PROJECT: Dexter Community Schools
PEMB – BP2

RE: ADDENDUM 2

Date	January 16, 2026
Project Name	Dexter Community Schools – Dexter High School New Field House
TMP Project No(s).	25026E
Bid Package No.	One(1) – PEMB
Addendum No.	One(1)

10 S4.1 TYPICAL EXTERIOR FOOTING
NOT TO SCALE

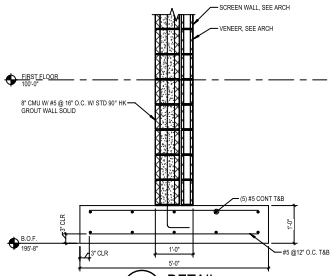
Item No.	**Structural Drawing Changes**
SD-1	Refer to Drawing No. S4.1 (reissued): A. Refer to Detail 10/S4.1. Revised pier and concrete tie depth as indicated. Please note, this was included in the RFI 11 response. B. Refer to Concrete Pier Schedule. Added top of pier elevations as indicated. Please note, this was included in the RFI 11 response.
SD-2	Refer to Drawing No. S6.1 (reissued): A. Refer to Detail 5/S6.1. Revised metal panel callout as indicated. Added note as indicated, please note this was included in the RFI 10 response. B. Refer to Detail 6/S6.1. Revised metal panel callout as indicated.

A4.2

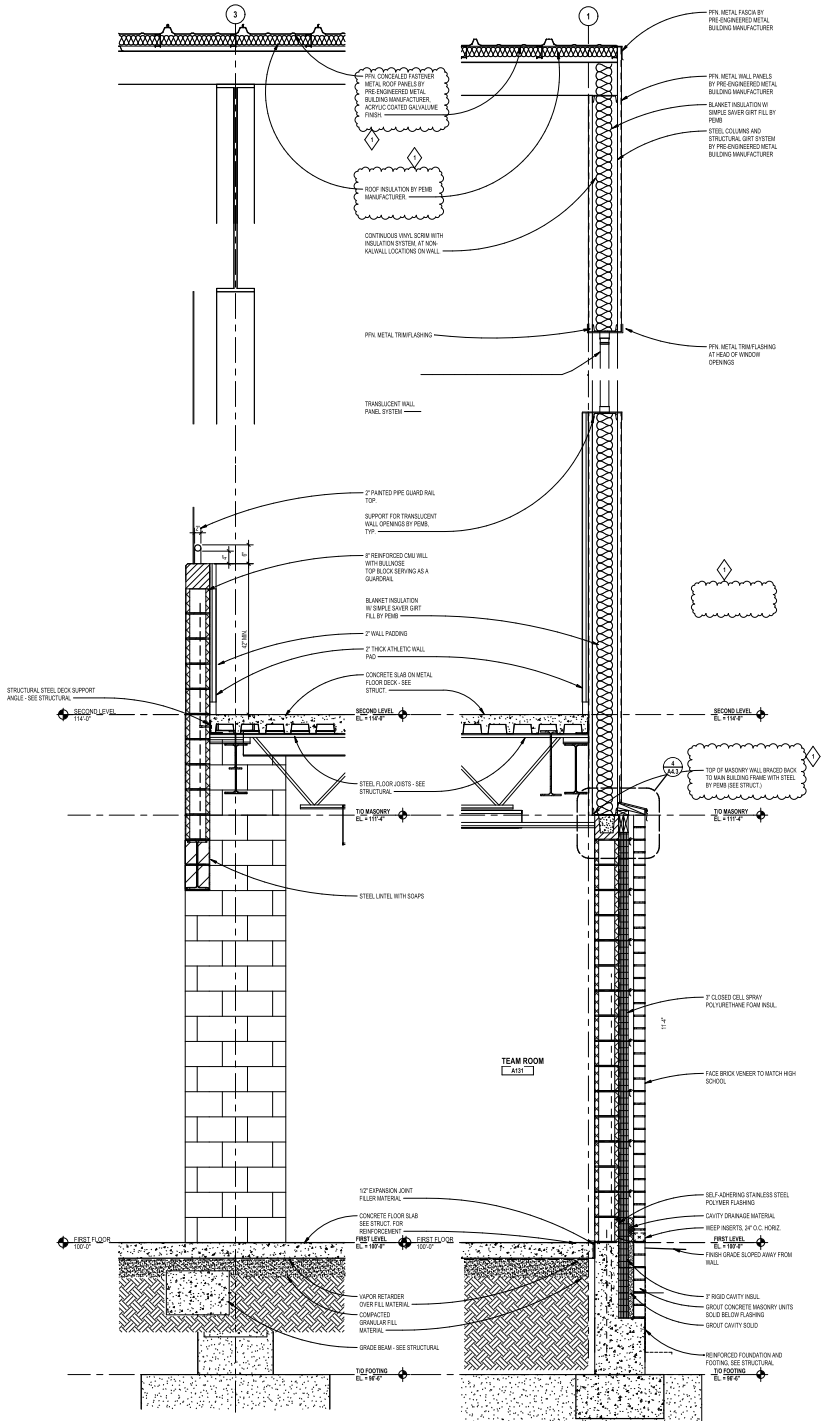
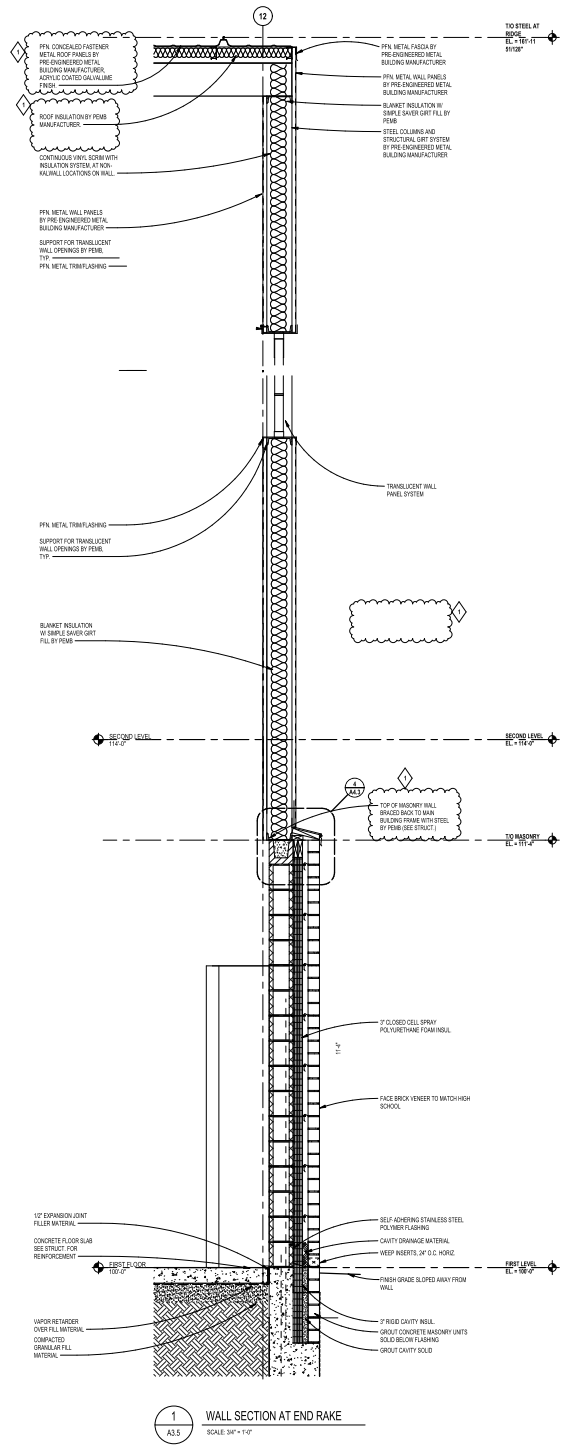
Item No.	Architectural Drawing Changes
AD-1	Refer to Drawing No. A4.2 (reissued): A. Refer to Detail 1/A4.2. Removed note referring to ACM panels. Revised roof deck notes, roof finish and top of masonry wall notes as indicated. B. Refer to Detail 2/A4.2. Removed note referring to ACM panels. Revised roof deck notes, roof finish and top of masonry wall notes as indicated. C. Refer to Detail 3/A4.2. Revised roof deck notes and roof finish notes as indicated. D. Note: these revisions are typical and should be applied to all wall sections where applicable.
